Cessna 150, F150, 152 & F152 Series Aeroplanes

AD/CESSNA 150/45

STOL Conversion Wing Stall Fence

10/96

Note 2. The diagram below is extracted from the FAA AD for guidance.

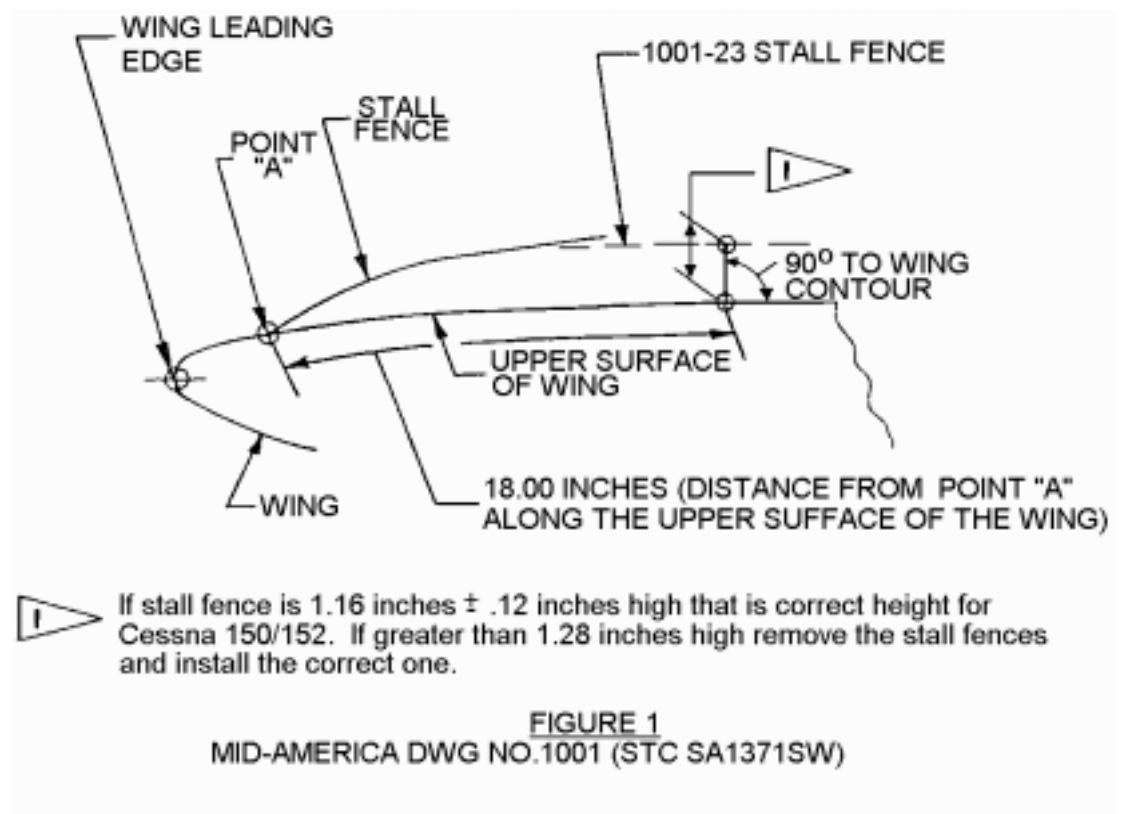
Requirement: Measure the height of the wing stall fence at the trailing edge. If the height exceeds 32.5 mm (1.28 inches) install a smaller fence in accordance with a scheme approved pursuant to CAR35 through a District Office of the Authority.
